**SUBJECT: Proposed
Amendment to Hermiston TSP**

AN ORDINANCE AMENDING THE HERMISTON TRANSPORTATION SYSTEM PLAN THROUGH THE ADOPTION OF THE 2016 AMENDMENT TO THE SOUTH HIGHWAY 395 CORRIDOR REFINEMENT PLAN.

**TSP Project Recommendations
Hermiston TSP Update - Ranch & Home**

Re: City of Hermiston Transportation System Plan Update – Ranch and Home Development

**FIGURE 1
CURRENT CONFIGURATION**

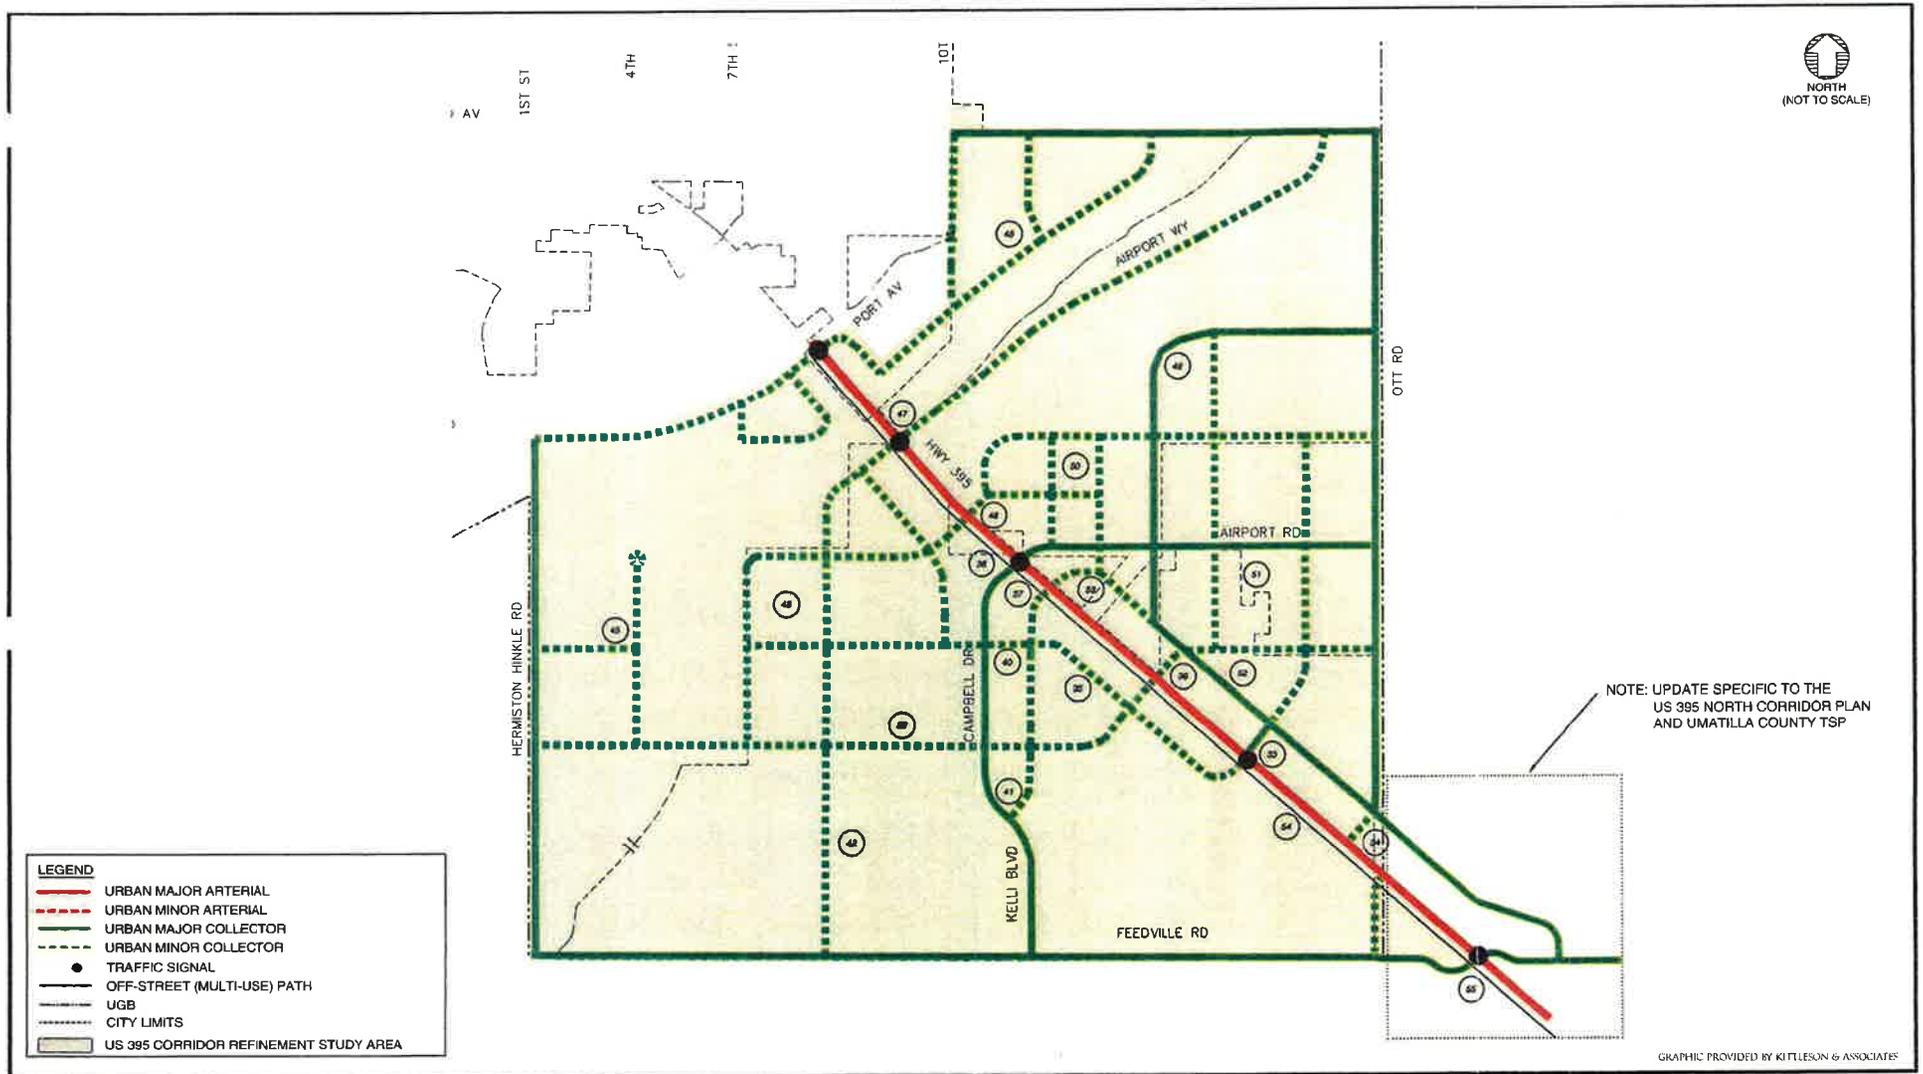
The existing circulation plan for the south Highway 395 corridor is attached to this report as figure 1.

**FIGURE 2
AMENDED CONFIGURATION**

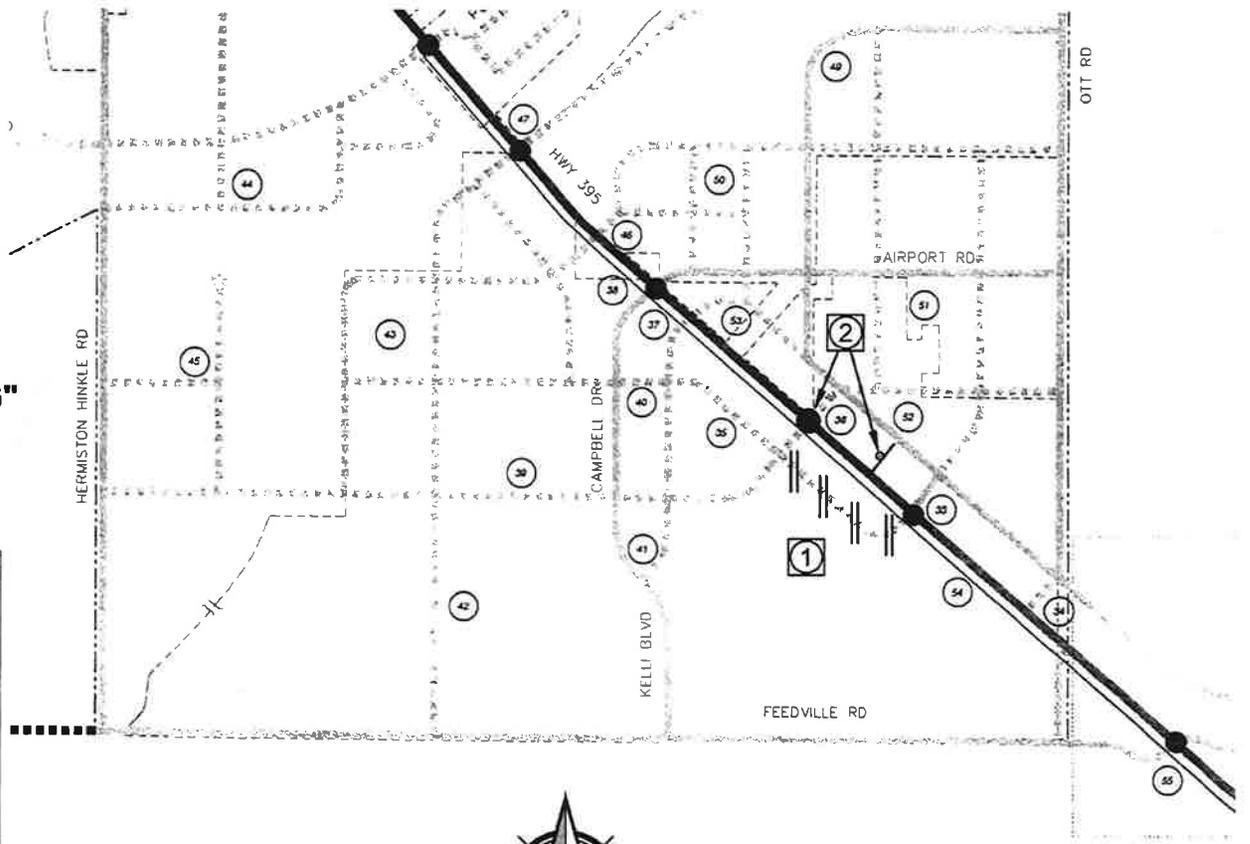
A copy of the revised layout is included in the attached Figure 2. The new signal is highlighted by the number 2 in a squared circle. Additionally, the removal of a planned parallel backage road for Highway 395 is marked by dual strikethrough lines in the graphic.

- ① **REVISE PROJECT TO SHORTEN 35.**
- ② **REVISE PROJECT 36 TO INCLUDE FULL ACCESS SIGNAL WITH "PREPARE TO STOP WHEN FLASHING" SIGN.**

FIGURE 2

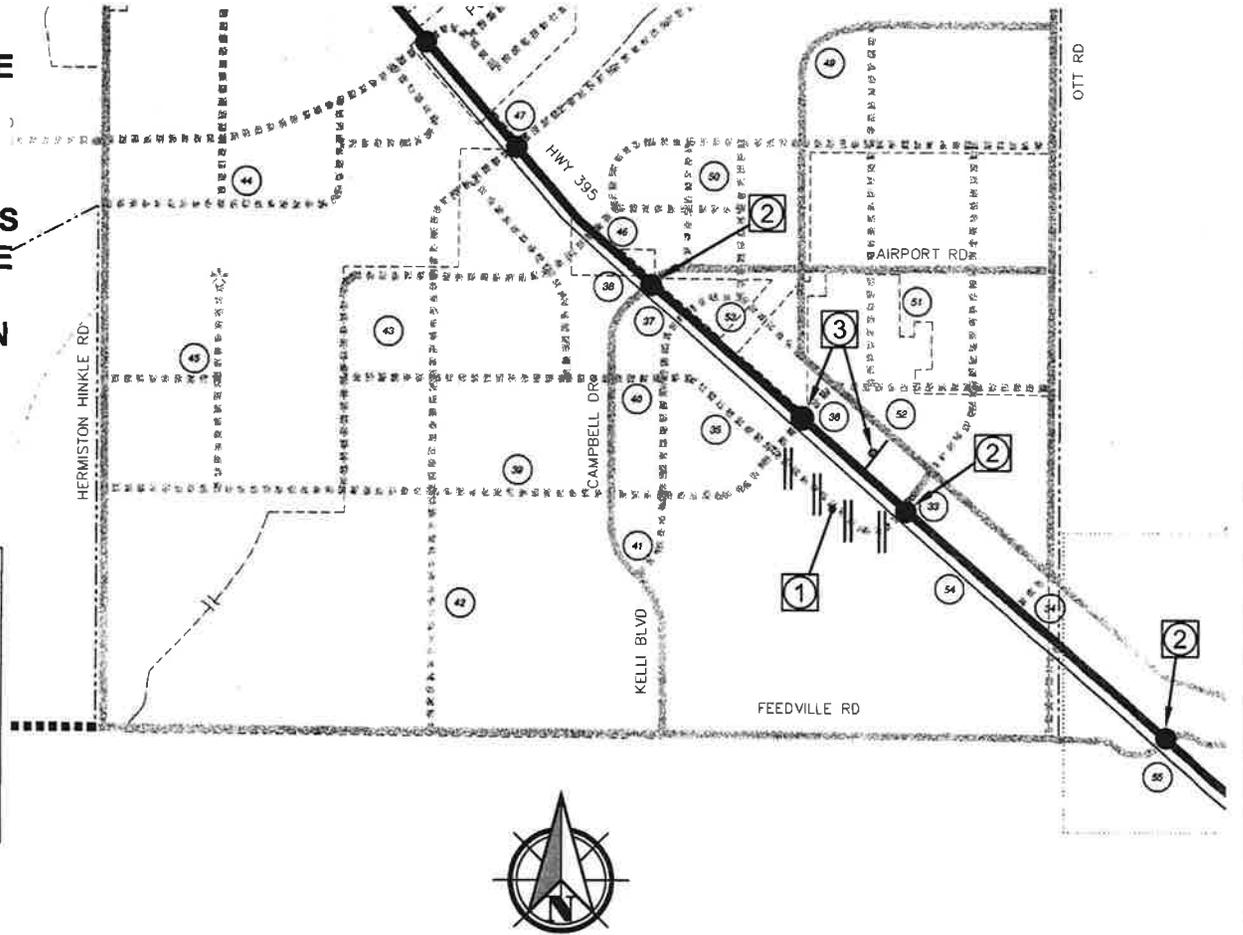
Revise City of Hermiston’s Transportation System Plan project listed as follows and illustrated in Figure 2:

1. Modify Project 35 to shorten proposed minor collector backage road, parallel to US 395, between Kelli Boulevard to the proposed minor arterial listed as Project 39 (Hermiston Foods driveway).
2. All TSP projects within the US 395 corridor that call for a signal shall include a roundabout as the preferred alternative. This includes specific projects listed in the 2003 TSP Update, such as Project 33 at the Walmart Entrance, Project 38 at Campbell Drive/Airport Road intersection, and Project 55 at the Feedville Road intersection.

3. Modify project 36 to include a full access traffic signal or roundabout at the proposed minor arterial intersection with US 395, near the Hermiston Foods driveway. A roundabout shall be considered as the preferred alternative to the proposed traffic signal. If a traffic signal is the most feasible for the Ranch and Home Development and the Hermiston Foods driveway, it should include an advance warning sign assembly “PREPARE TO STOP WHEN FLASHING” and advance vehicle detection system.

- ① REVISE PROJECT TO SHORTEN 35.
- ② REVISE PROJECT 33, 38, & 55 TO INCLUDE A ROUNDABOUT AS THE PREFERRED ALTERNATIVE TO A SIGNAL.
- ③ REVISE PROJECT 36 TO INCLUDE ROUNDABOUT AS PREFERRED ALTERNATIVE OR TRAFFIC SIGNAL WITH "PREPARE TO STOP WHEN FLASHING" SIGN.

FIGURE 3

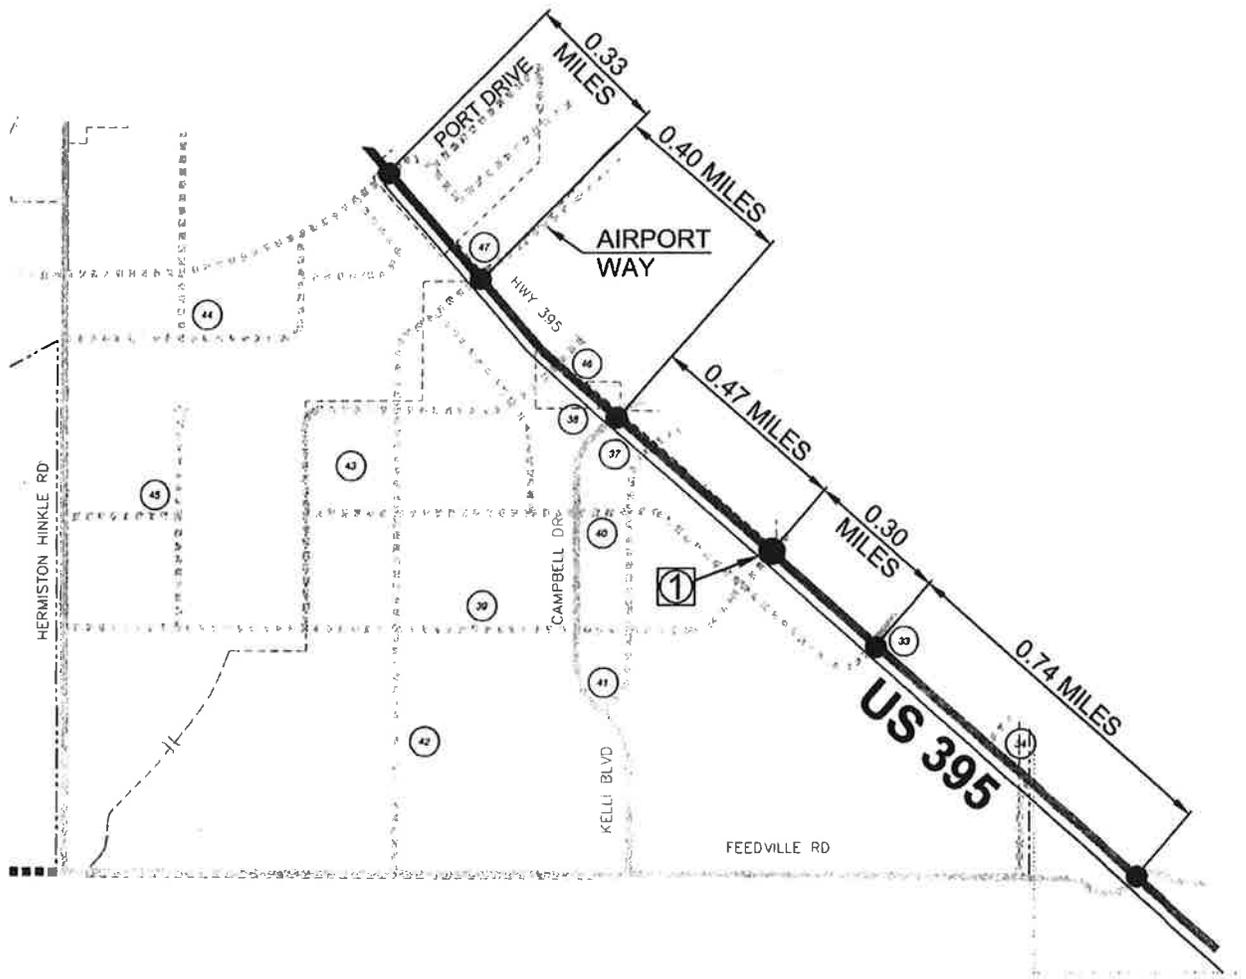
① New traffic signal at Hermiston Foods entrance.
